# OCP NIC 3.0 Design Specification

Version 0.910-90

Author: OCP Server Workgroup, OCP NIC subgroup

Figure 35: SFF Bottom Side Insulator (Top and Side View)

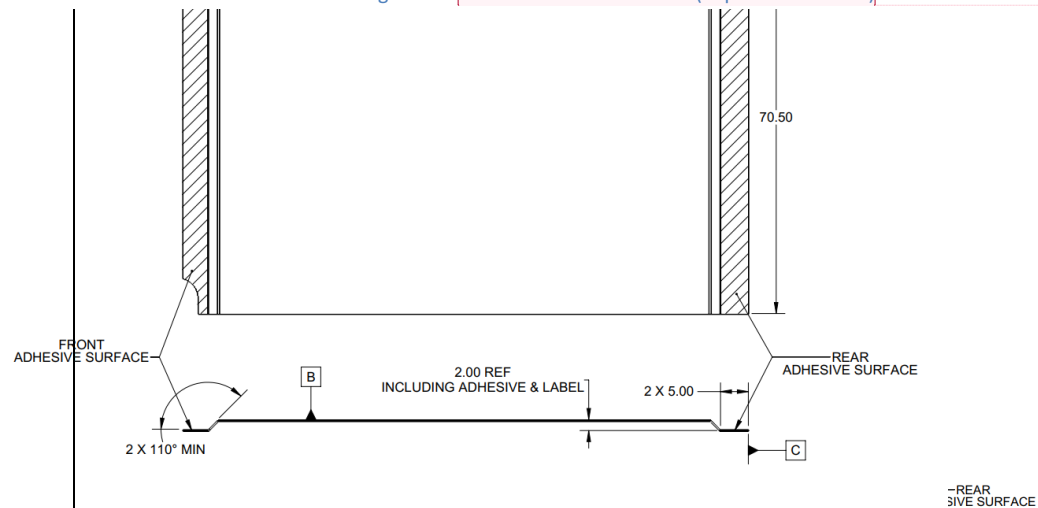
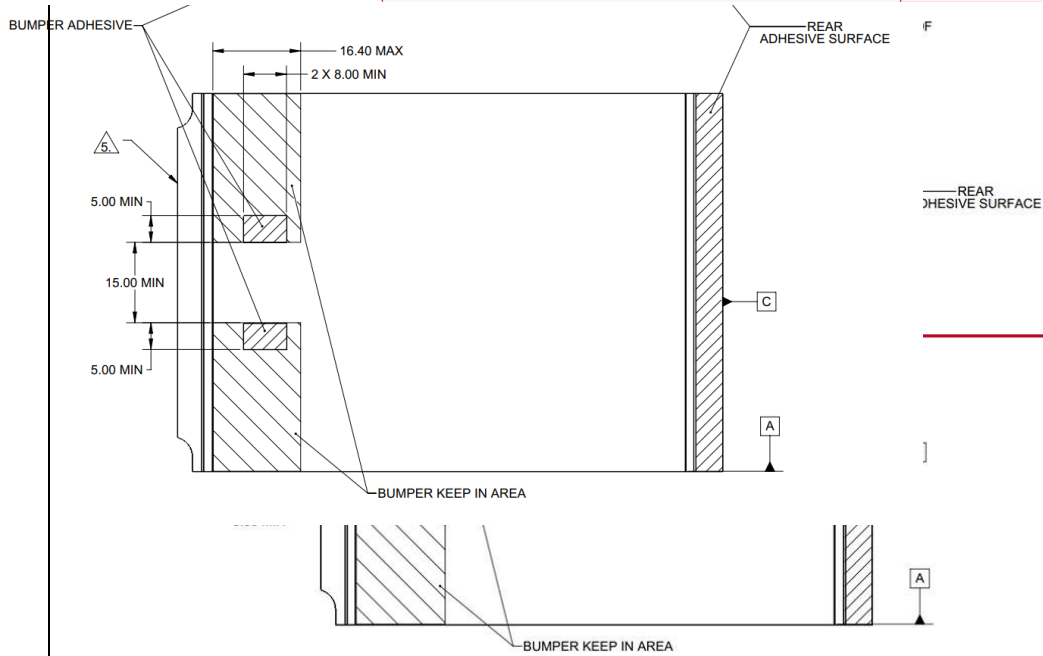
**Commented [NT3]:** 0v91 Fix: Extend SFF & LFF insulator drawings.

"FRONT EDGE OF INSULATOR AND ADHESIVE MAY EXTEND TO 107.6 MM IF NECESSARY TO PROTECT LEDS ON SECONDARY SIDE OF PCBA"

Figure 38: LFF Bottom Side Insulator (Top and Side View)

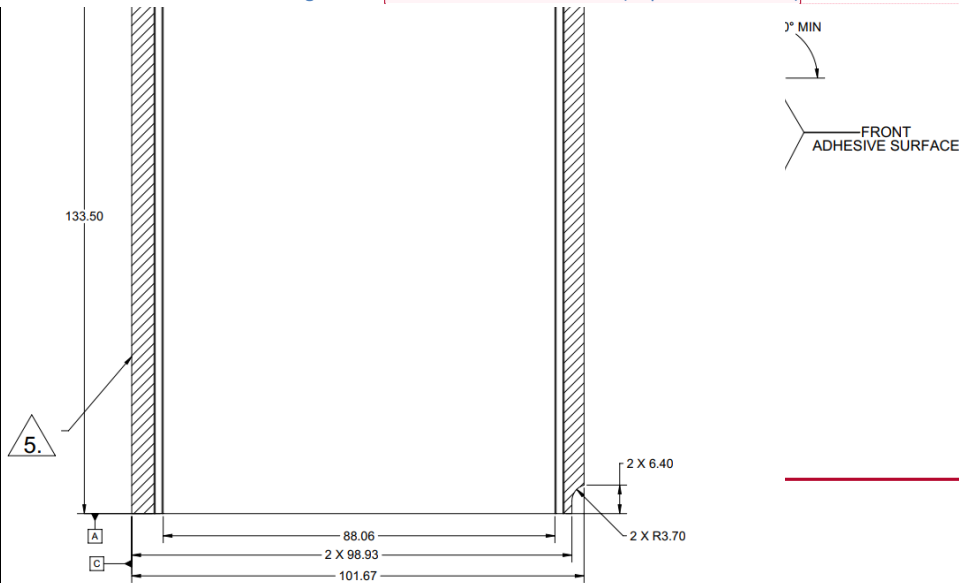
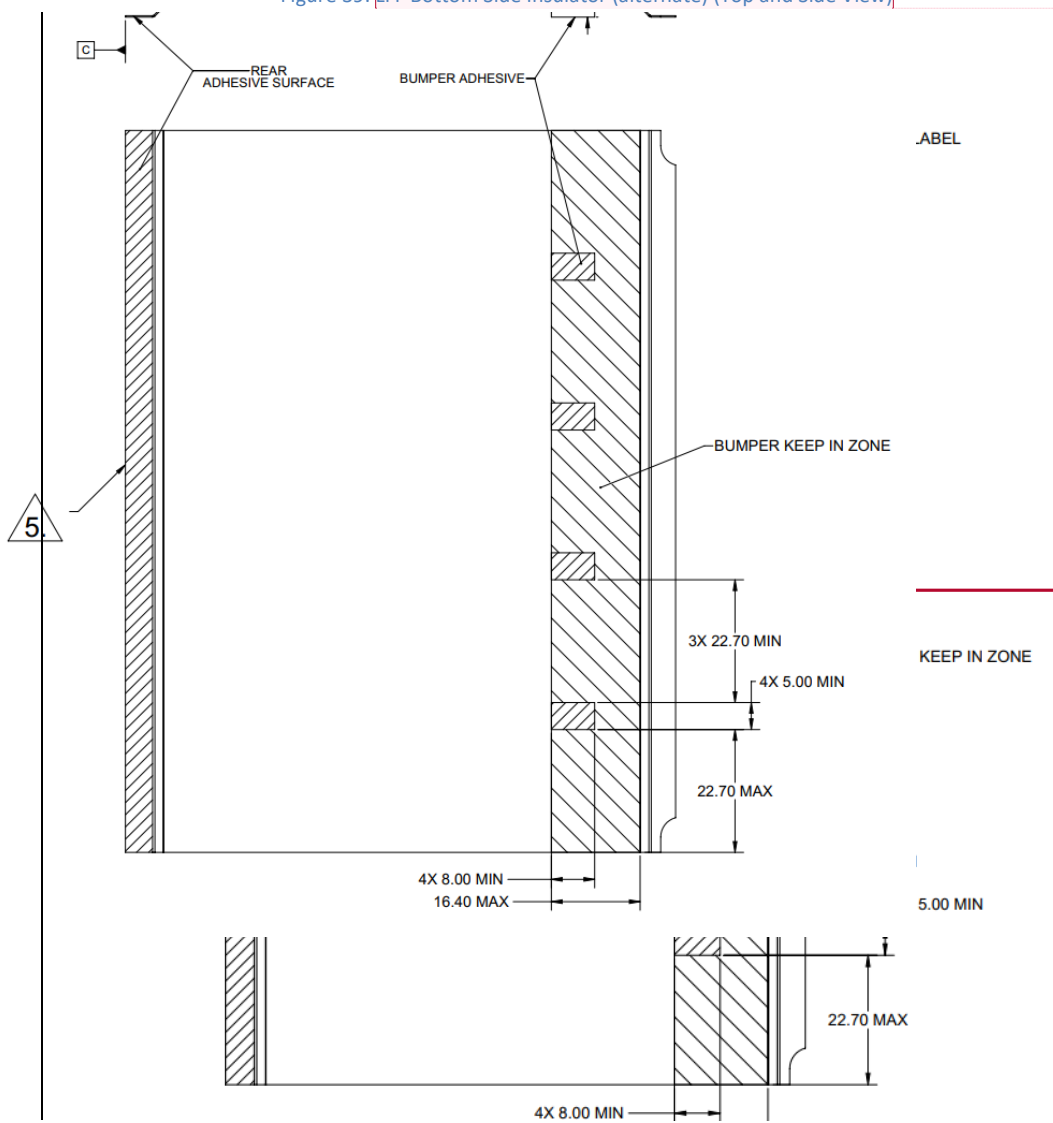
"FRONT EDGE OF INSULATOR AND ADHESIVE MAY EXTEND TO 107.6 MM IF NECESSARY TO PROTECT LEDS ON SECONDARY SIDE OF PCBA"
